Title		
Dennis Koller		
Size	Document Number	Rev
B	NMS8280 Genlocker	<Rev Code>
Date:	Friday, December 24, 2004	Sheet 1 of 1

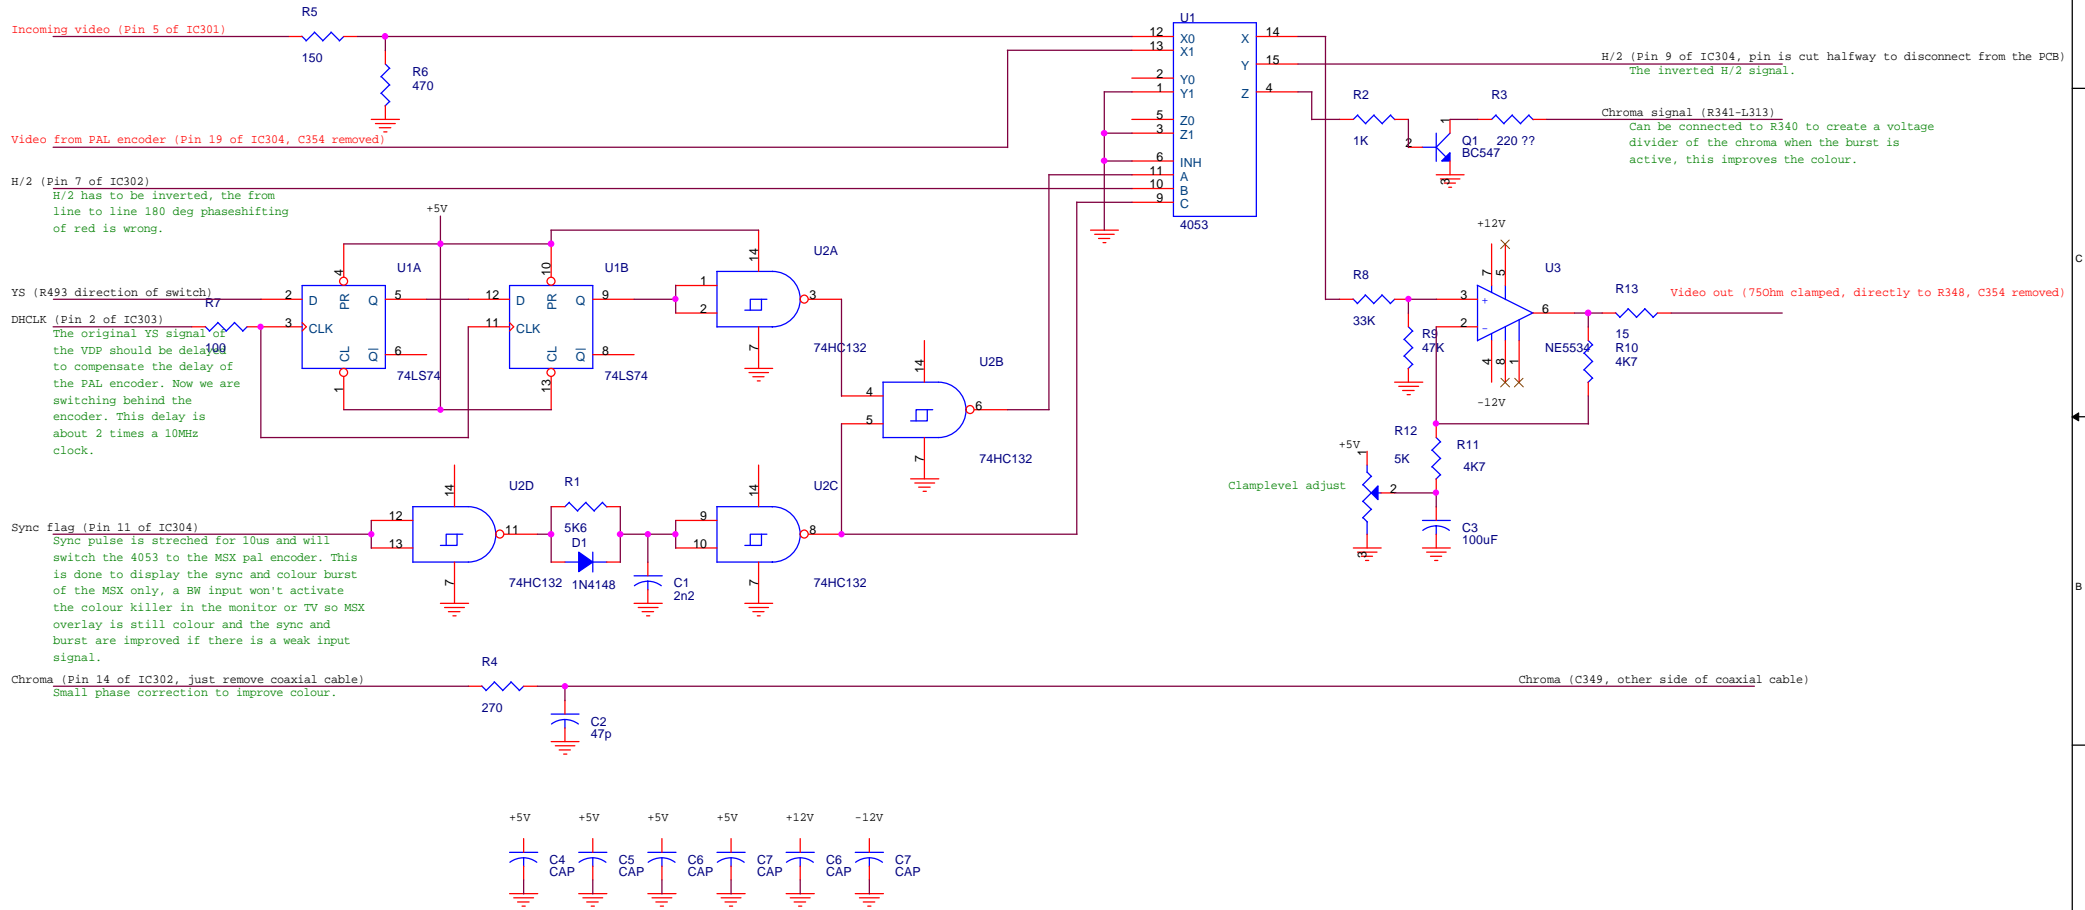
YS: pin 25 of IC304 cut halfway and connected to pin 24 of the same device. By holding this input high the encoder won't switch to external.
 Video out: C354 and C364 are disconnected to reduce the load. C354 can be removed, C364 should be disconnected on the + side the final CVBS signal can be connected to the + pin again for the UHF modulator.

Filter & pal decoder in original state to keep digitizing possible. Improving PAL decoder filter gives aliasing in ADC
